# Final Product/Process Change Notification

Document #:FPCN23609X

<b>Title of Change:</b>	Second source site addition for final test and shipping tray change for AR0330 CSP products.
<b>Proposed First Ship date:</b>	23 Apr 2021 or earlier if approved by customer
<b>Contact Information:</b>	Contact your local ON Semiconductor Sales Office or <a href="mailto:Geethakrishnan.Narasimhan@onsemi.com">Geethakrishnan.Narasimhan@onsemi.com</a>
<b>PCN Samples Contact:</b>	Contact your local ON Semiconductor Sales Office or <a href="mailto:PCN.samples@onsemi.com">&lt;PCN.samples@onsemi.com&gt;</a> . Sample requests are to be submitted no later than 30 days from the date of first notification, Initial PCN or Final PCN, for this change. Samples delivery timing will be subject to request date, sample quantity and special customer packing/label requirements.
<b>Additional Reliability Data:</b>	Contact your local ON Semiconductor Sales Office or <a href="mailto:Amy.Wu@onsemi.com">Amy.Wu@onsemi.com</a>

*Original Case Outline Drawing (2inch Tray)*

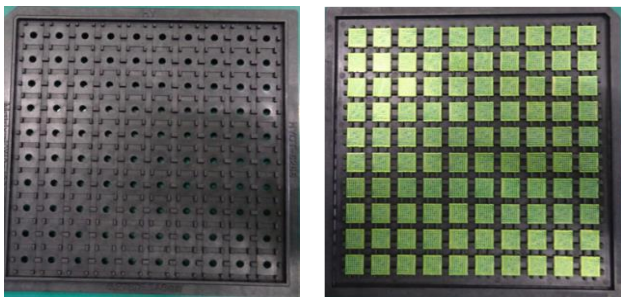
There is no product marking change as a result of this change. The difference in appearance of the tray is shown below.

2inch : 5\*5=25ea

4inch : 10\*10=100ea
